**REQUEST**

Current Zoning: N1-A (neighborhood 1-A)  
Proposed Zoning: N1-E(CD) (neighborhood 1-E, conditional)

**SUMMARY OF PETITION**

The petition proposes to develop two duplex buildings and two triplex buildings on parcels that are mostly vacant with one single family home.

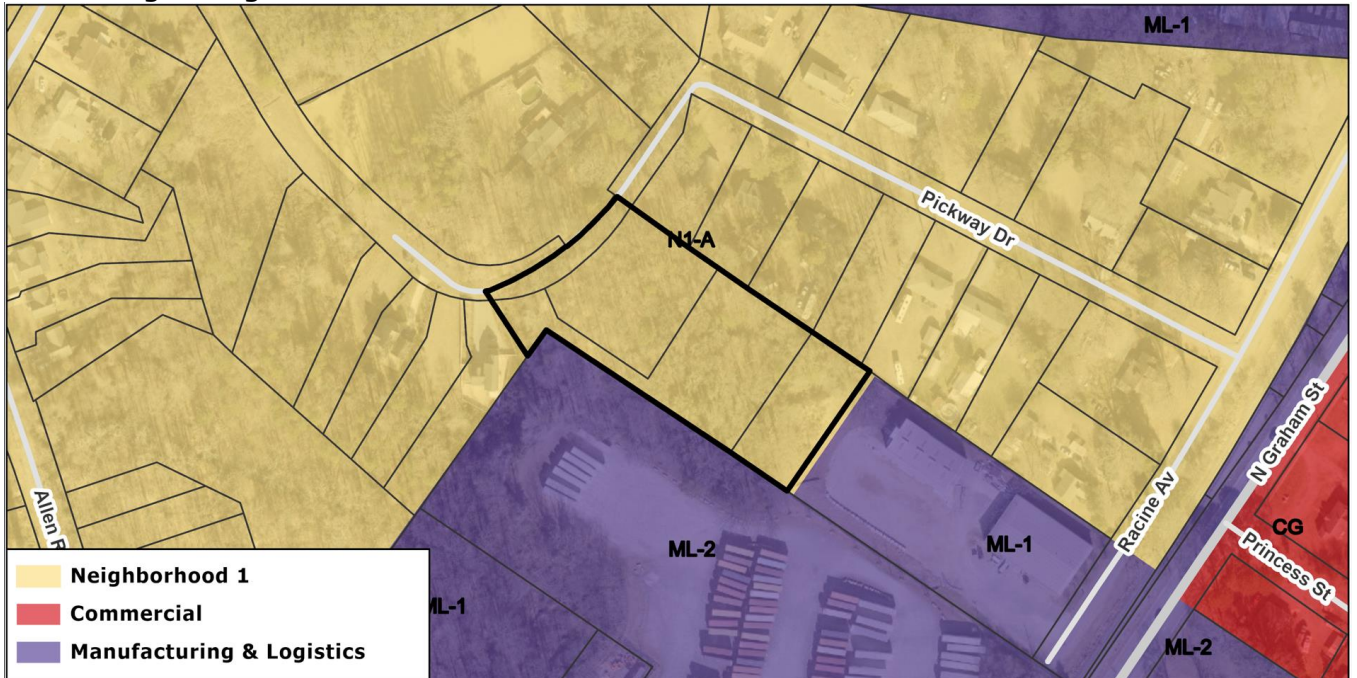
4. Specify **in the conditional notes what type of planting standards will be provided** in the rear setback against PID 04517220 **and along the side of lot 4C**. Consider adding conditional notes for planting standards that mirror the standards outlined for Class B or Class C Landscape Yards. ~~Add a 6' opaque wooden fence along the site's boundary against PID 04517220.~~

6. Modify the driveways shown for the triplex buildings to be compliant with Article 19.6.A.1.a.

8. Clearly distinguish and label each building as being on its own lot. Sublots for the individual units should be distinguished by dashed lines.
